**Australian Government**  
**National Capital Authority**

**Draft Consultation Report**  
**Works Approval No 100130**  
**Block 19 Section 7 Forrest – 47**  
**National Circuit**  
**Construction of Dual Occupancy**

*April 2017*

Landscape Plan

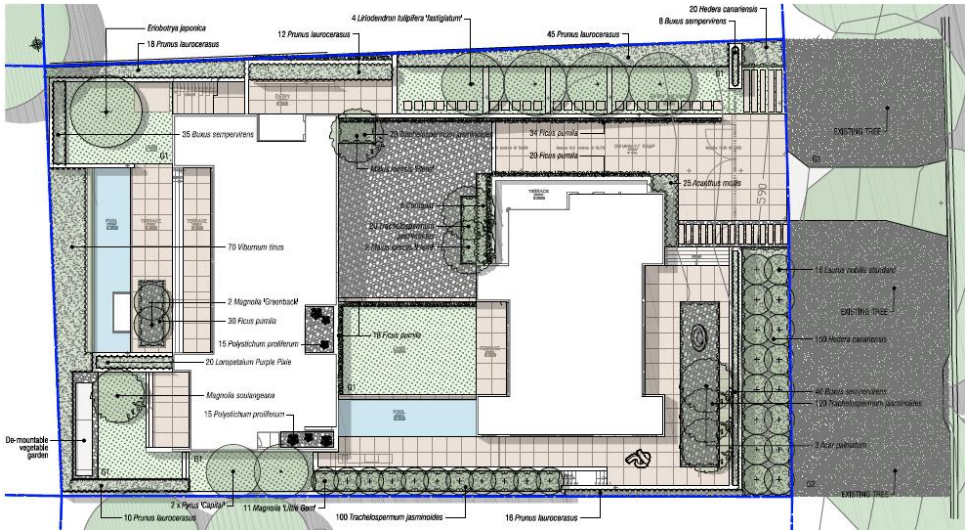
2.11	We also question the accuracy of the soft landscaping areas as the landscape plan appears to indicate less than the 510m <sup>2</sup> quoted. Independent valuation of all areas should occur.	The applicant has provide an amended landscape plan indicating the site coverage of the soft landscape (excluding walls, paved areas, pool and driveway) including the grassed area over the lower ground level is 601m <sup>2</sup> .
